REMARKS

Fig. 5

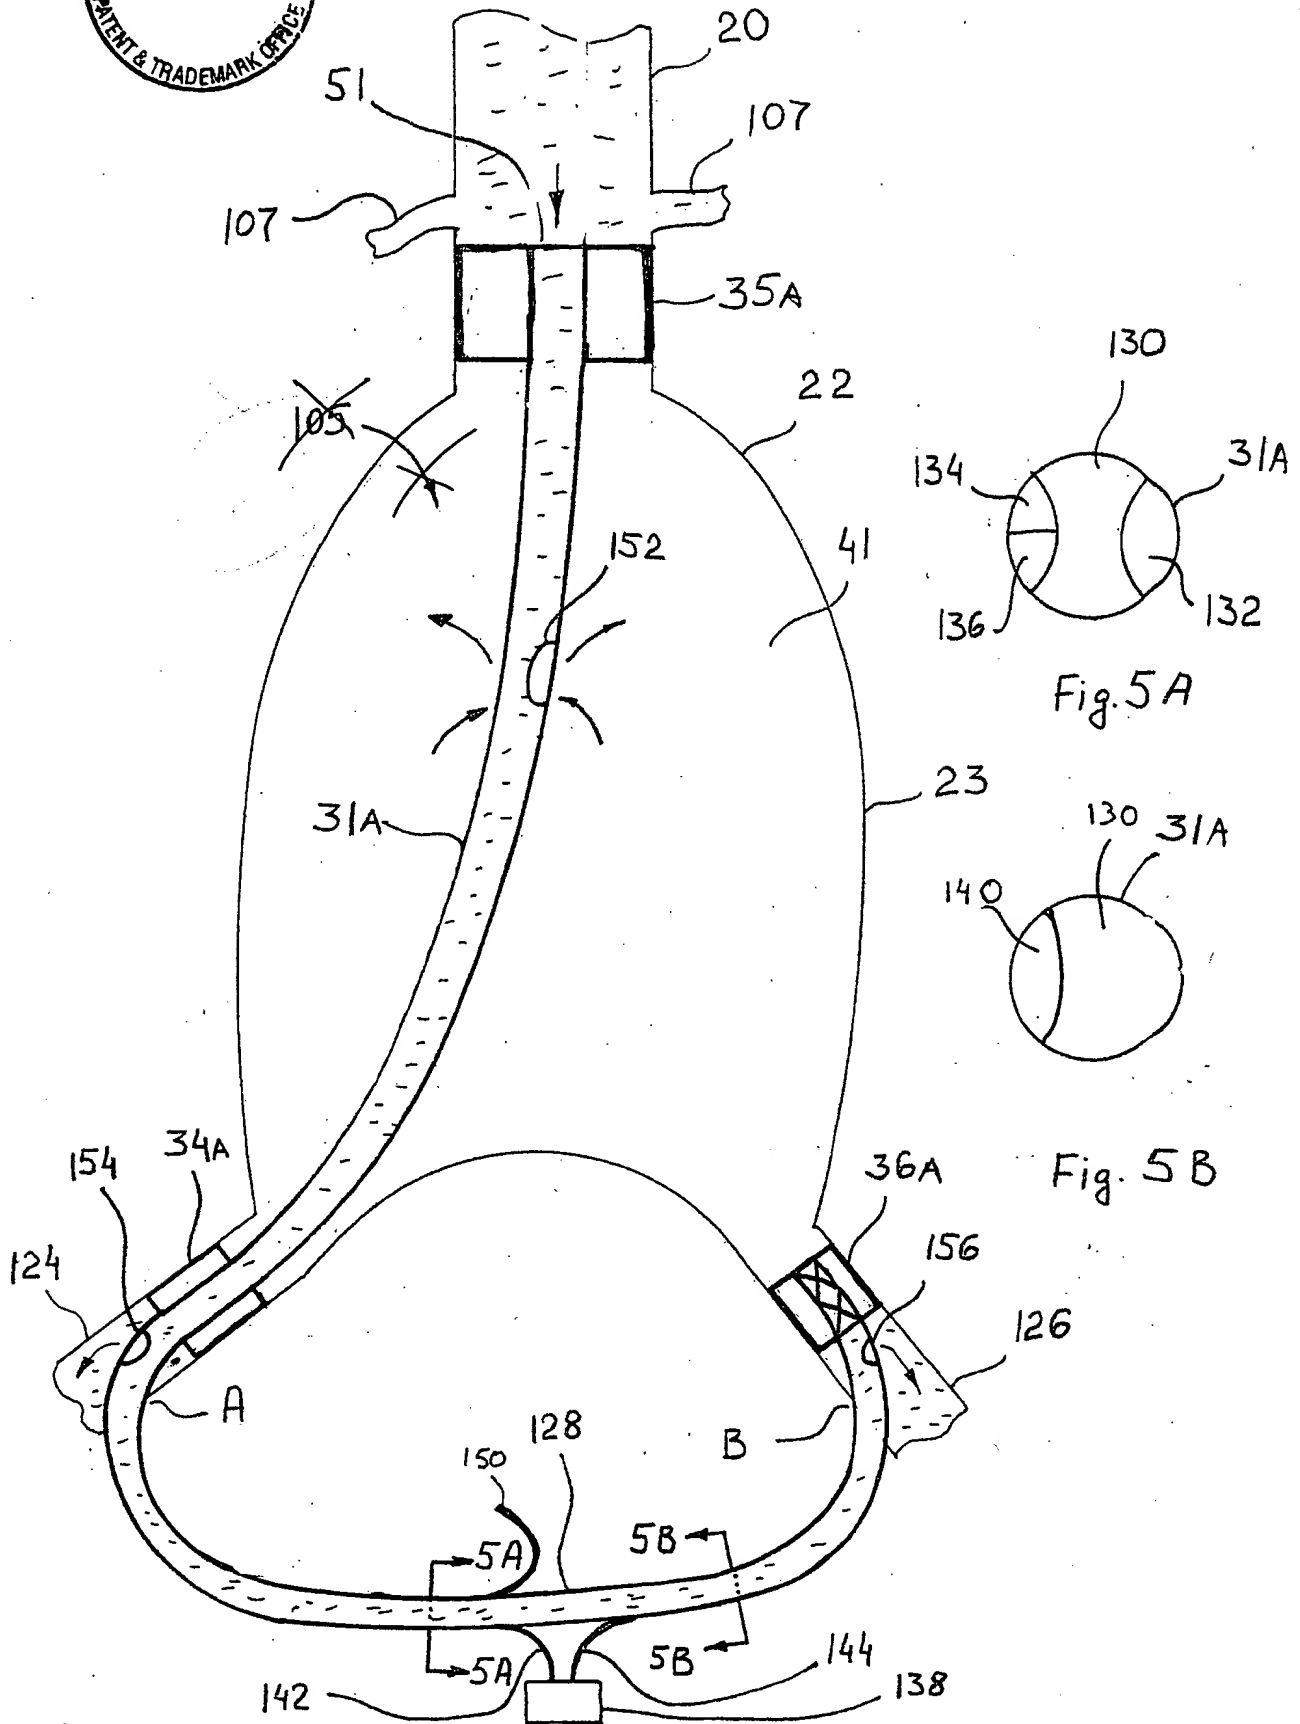
The Examiner objected to the drawings because figure 5 shows reference numeral "105". Red-lined amended figure 5 is herein submitted with this number crossed out. The Examiner also objected to the drawings for failure to include reference numbers "111" and "119" in the drawing. Reference numerals "111" and "119" have been removed from the specification. Accordingly, it is respectfully requested that these objections be withdrawn.

Approved
Cfr 2/13/03
